**California Traffic Control Devices Committee (CTCDC)
Agenda Item Report**

Meeting Date: May 7, 2026 Item Number: 26-05	From: Kathryn Kleinschmidt, Caltrans
Sponsored By: Devang Vora, Caltrans	Presented By: Kathryn Kleinschmidt, Caltrans
Description: Caltrans District 5 requests CTCDC approval for a new word message sign "DO NOT DRIVE BESIDE TRUCKS".

Motion by committee to recommend inclusion of the proposed "DO NOT DRIVE BESIDE TRUCKS" sign in a new CA MUTCD Section 2C.104(CA) "DO NOT DRIVE BESIDE TRUCKS Sign".

Figure 19: OR4-22 (DO NOT DRIVE BESIDE TRUCKS) Detail

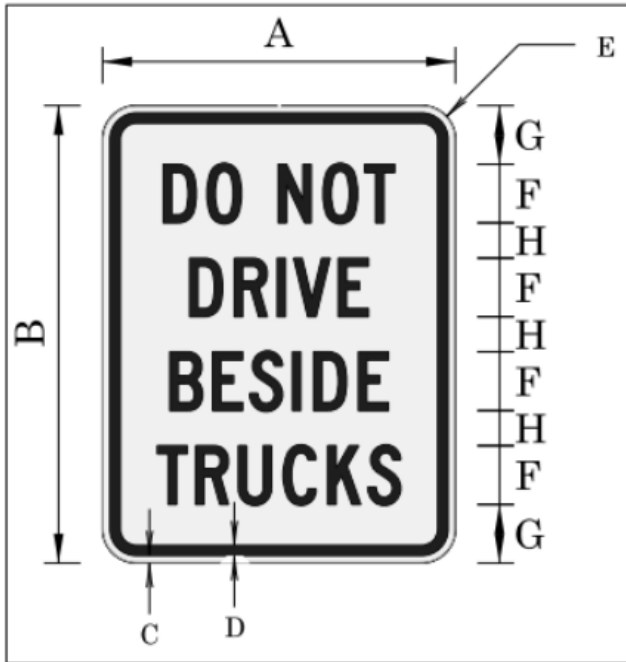
To help reduce the potential for sideswipe crashes in roundabouts due to off-tracking trucks, it is proposed to include a new sign in the CA MUTCD warning drivers not to drive beside trucks in a roundabout. The proposed "DO NOT DRIVE BESIDE TRUCKS" sign is modeled after a regulatory sign in Oregon (OR4-22). Section 811.292 of the Oregon Vehicle Code says that a motorist commits a failure to yield offense if they overtake, pass, or drive alongside a commercial motor vehicle in a roundabout; and Section 810.247 requires a road authority to place signs prior to each multilane

Proposed SW61(CA) Sign:

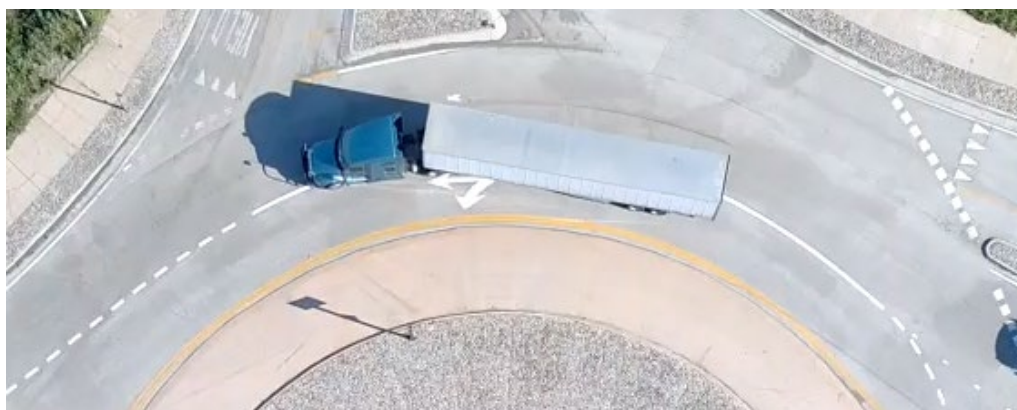
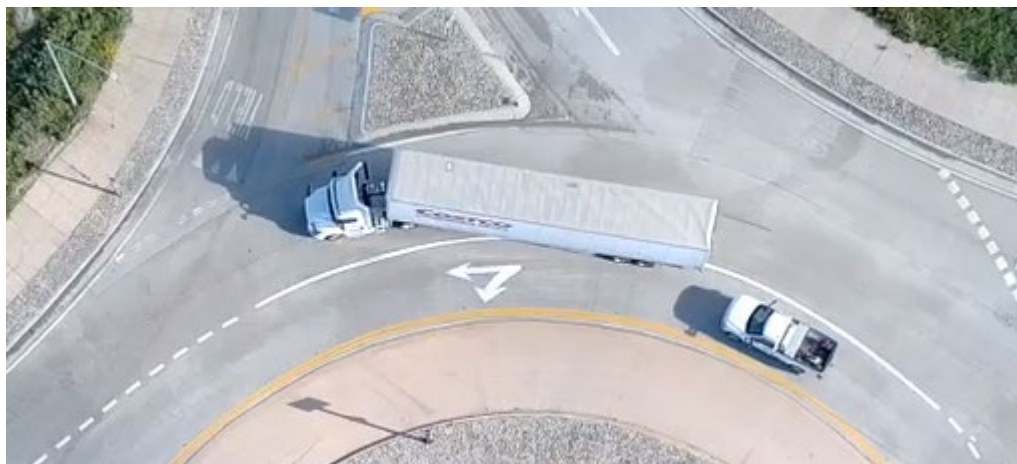
⁰¹ The DO NOT DRIVE BESIDE TRUCKS (SW61(CA)) sign (see Figure 2C-6(CA)) may be used in advance of a multilane roundabout where there is potential for commercial vehicle off-tracking.

⁰² The DO NOT DRIVE BESIDE TRUCKS sign may be installed alone on the approach to a multilane roundabout or mounted below another sign, such as an Intersection Lane Control (R3-8 series) sign, as a supplementary plaque on the same post.

Section 2C.104(CA) DO NOT DRIVE BESIDE TRUCKS Sign (SW61(CA))
